Description: each time,after chainsaw plate/bar goes back to original position,set 1 second to release residual pressure of throttle valve and hydraulic cylinder.so there isn't any residual pressure of chainsaw plate/bar when cutting.

Here are steps of changing parts

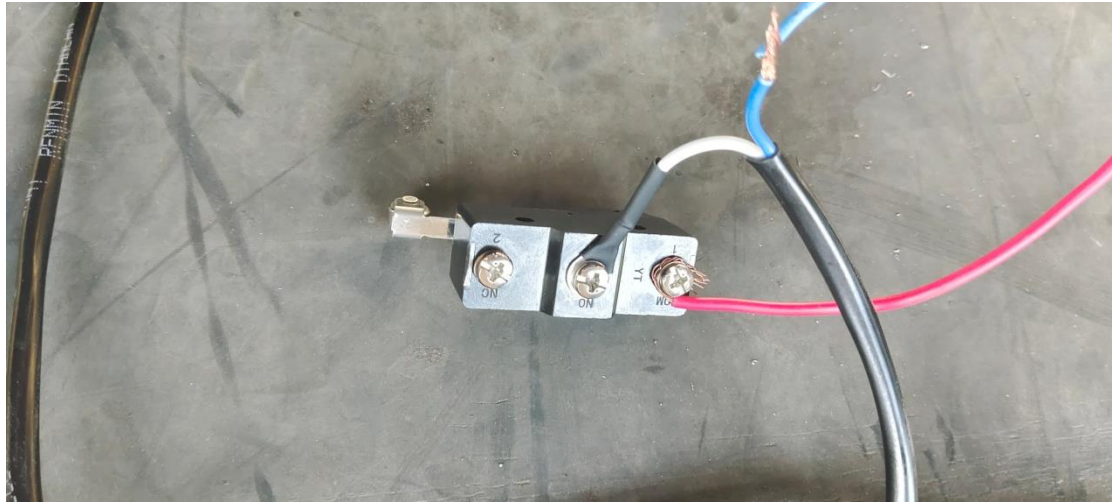
1.Disassemble hoses and nipple with rod cavity of cutting cylinder ,changing to new received nipple and hoses

Add 1/2 tee connector to tee connector on the front of filter

2、reconnect wire of original switch of chiansaw plate lubrication

Every time chainsaw plate/bar goes back to original position, it will activate the solenoid valve for about 1s by inching switch, then close.
